Re: 290 Binney Street – Bulk Gas Tank Farm and East Service Drive Circulation
Pattern Design Update

2-WAY DRIVE AISLE & BULK STORAGE YARD (290 BINNEY)

Design Review Submission

Re: KSURP Infill Development Concept Plan
Proposed Site Circulation Modification – August 2024
TIS Update Memo

Figure 1: 2021 Previously Approved Access/Circulation Plan

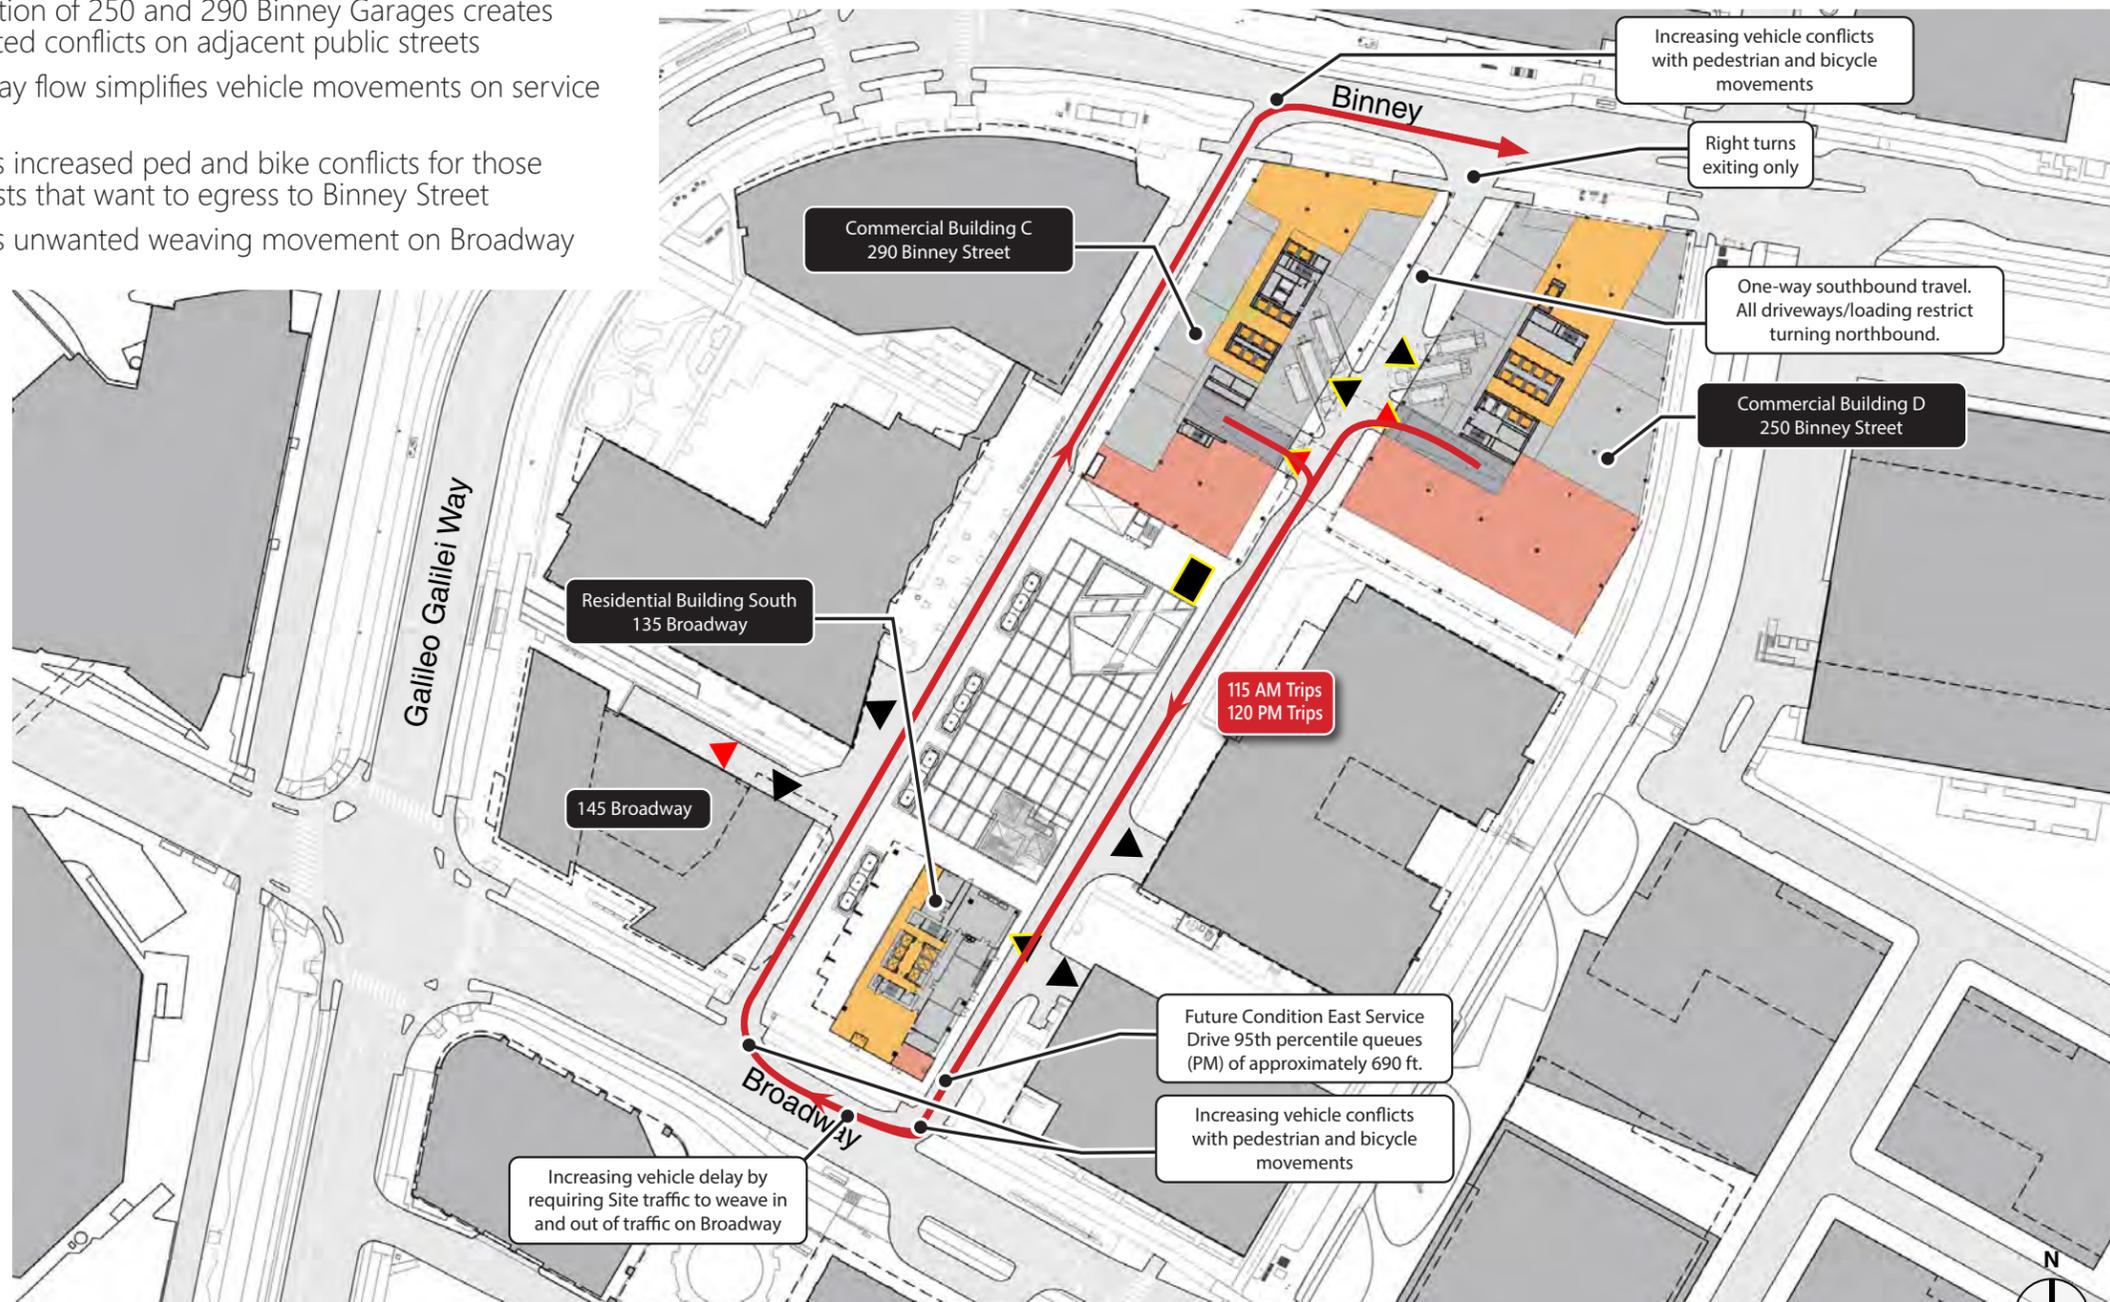
- Separation of 250 and 290 Binney Garages creates unwanted conflicts on adjacent public streets
- One-way flow simplifies vehicle movements on service drives
- Creates increased ped and bike conflicts for those motorists that want to egress to Binney Street
- Creates unwanted weaving movement on Broadway

Figure 2: Currently Proposed Modified Access/Circulation Plan

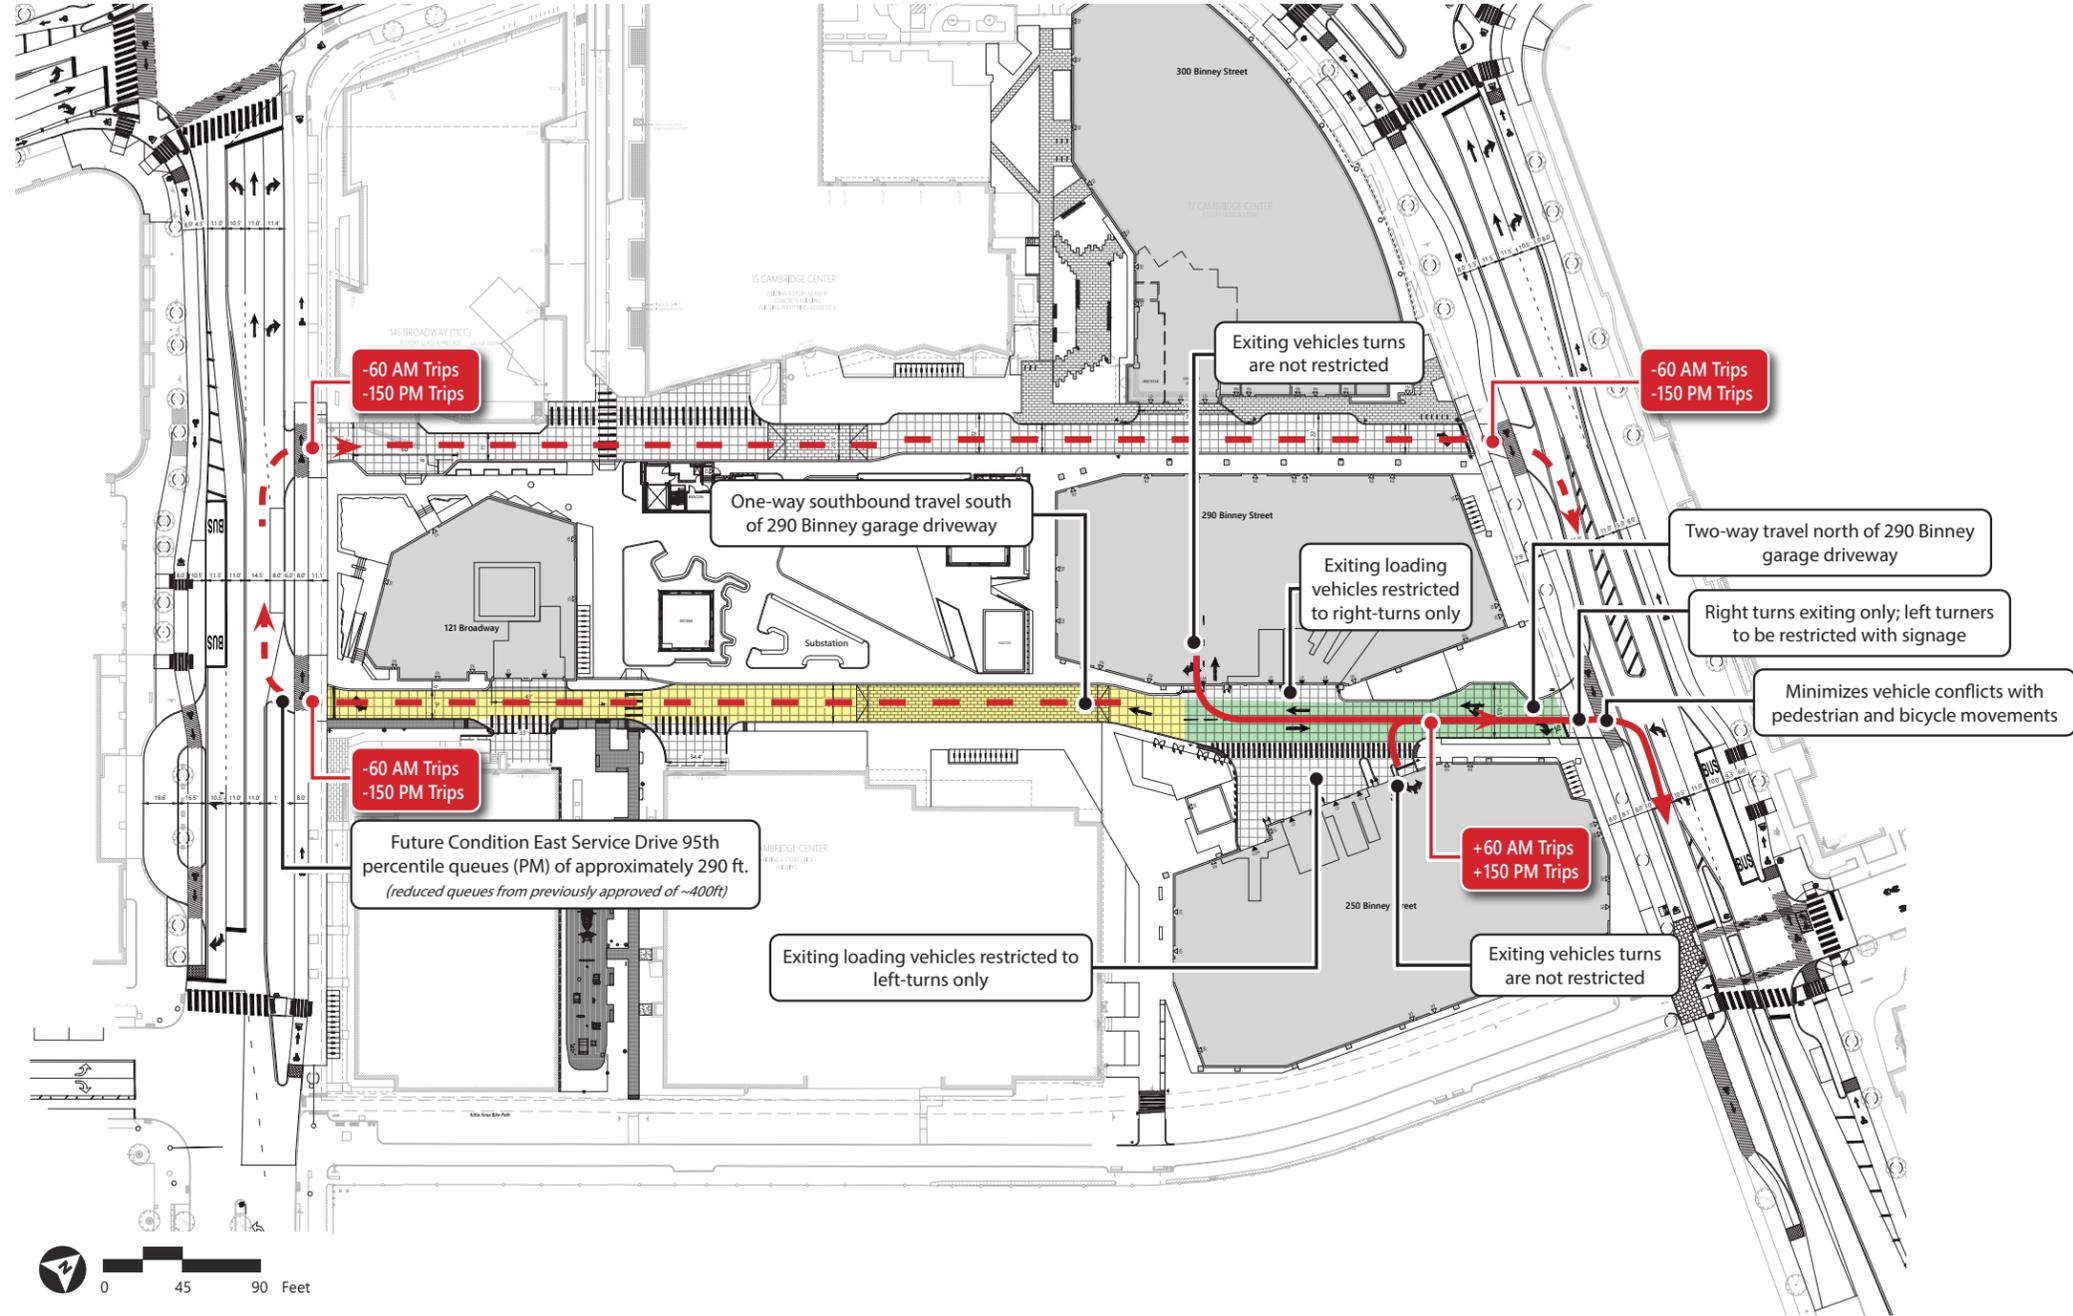
The Currently Proposed Modified Access/Circulation Plan contemplates a limited two-way segment of the East Service Drive from Binney Street to the 290 Binney Street Garage ramp. The purpose of this design update, again, is to maintain the most efficient internal site vehicle movements for those motorists that seek to egress back to Binney Street. Without this change, the approved site plan would require motorists to now exit towards Broadway and recirculate back onto the West Service Drive to get back to Binney Street.

- Exiting Vehicle route destined eastbound on Binney Street
- - → Eliminated movement to eastbound Binney Street
- One-way Circulation
- Two-way Circulation

Figure 1: 2021 Previously Approved Access/Circulation Plan

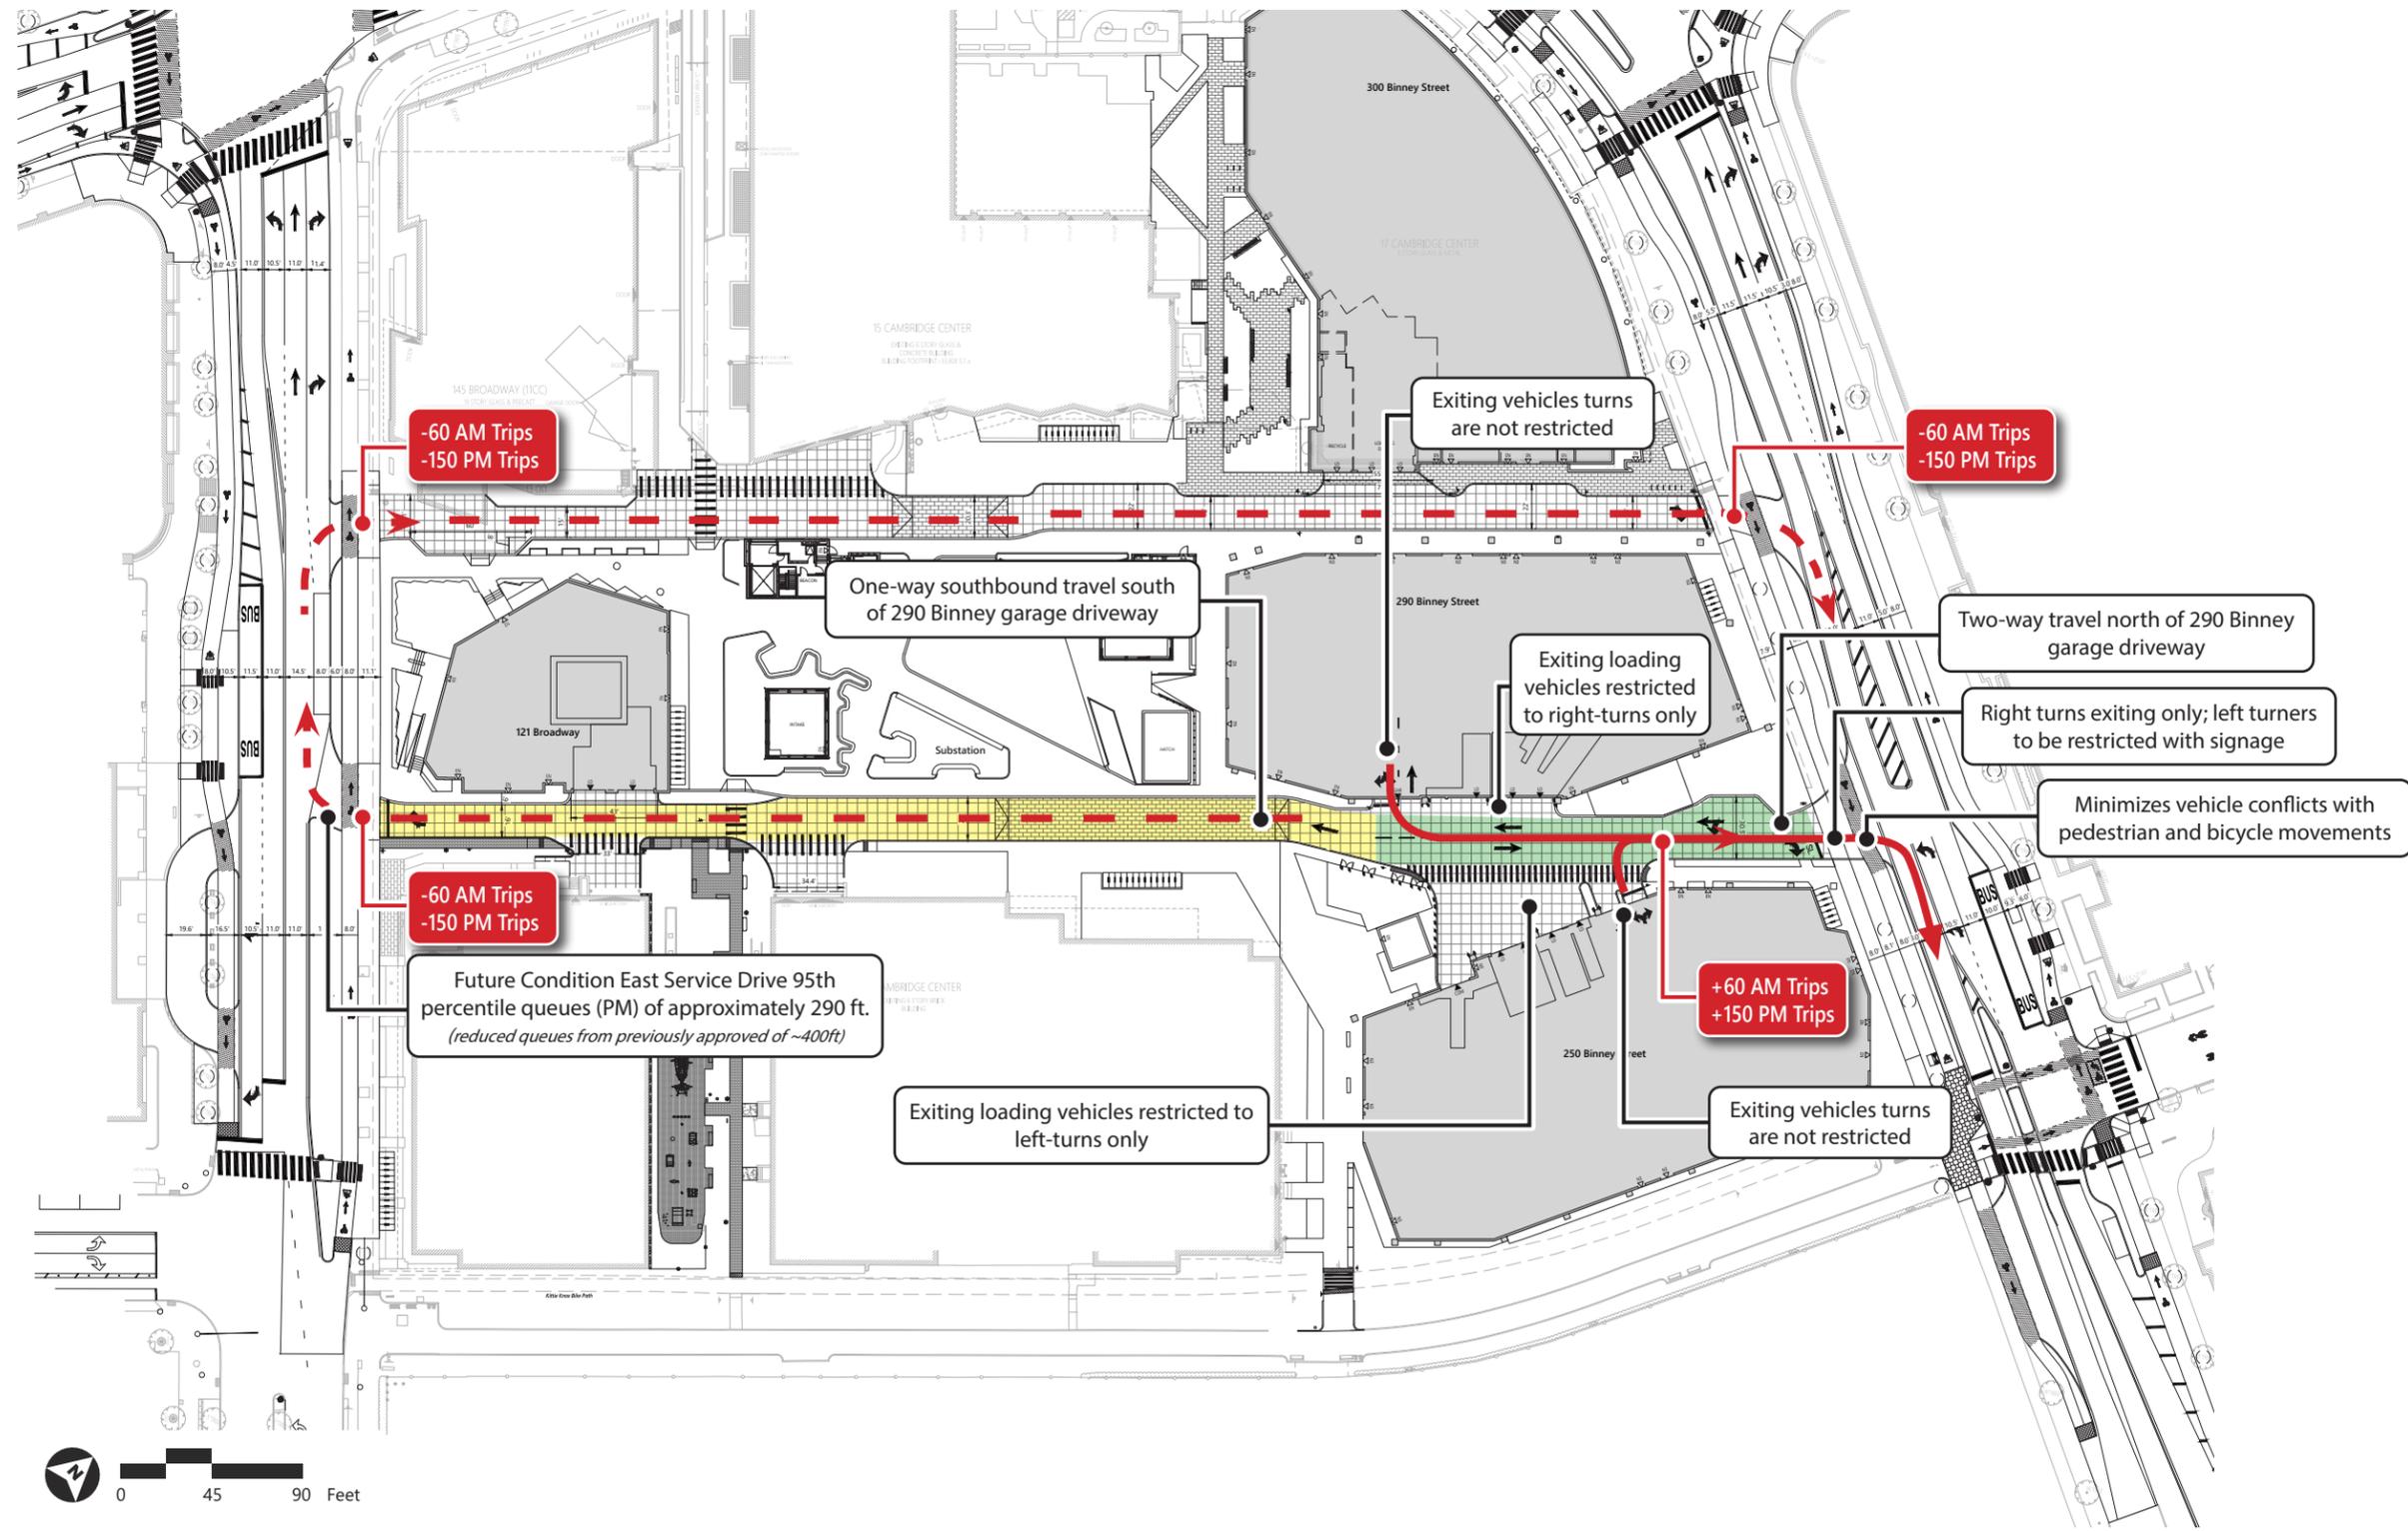
- Separation of 250 and 290 Binney Garages creates unwanted conflicts on adjacent public streets
- One-way flow simplifies vehicle movements on service drives
- Creates increased ped and bike conflicts for those motorists that want to egress to Binney Street
- Creates unwanted weaving movement on Broadway
